3GPP TSG_CN **Tdoc NP-000213**
Plenary Meeting #8, Düsseldorf, Germany
21st – 23rd June 2000.

Source:	**TSG_N1**
Title:	**LS on "GPRS ciphering "**
Agenda item:	**4.1**
Document for:	**INFORMATION**

To:	TSG-S3, TSG CN
cc:	SMG, TSG N4
Source:	TSG-N1
Title:	Reply to LS on "GPRS ciphering "
Date:	2000-05-26

Subject: Support of GEA/2 Encryption Algorithm

Figure 10.5.128/GSM 04.08: MS network capability information element

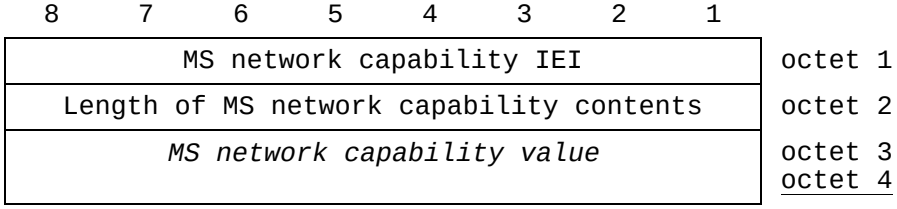
The *MS network capability* is a type 4 information element with a minimum of 3 and maximum of ~~3~~4 octets length.

Octet 4 shall be included by the MS, if it supports at least one of the GPRS Encryption Algorithm GEA/2 to GEA/7. Support of octet 4 is optional in the network.

<**GEA1 bits**>
<**SM capabilities via dedicated channels**: bit>
<**SM capabilities via GPRS channels**: bit>
<**UCS2 support**: bit>
<**SS Screening Indicator**: bit string(2)>
<SoLSA Capability : bit>
<**Spare bits**>
<**Spare bit**>
<Extended GEA bits>
<**Spare bit**>;

<Extended GEA bits> ::= <GEA/2:bit><GEA/3:bit>< GEA/4:bit >< GEA/5:bit >< GEA/6:bit ><GEA/7:bit>;
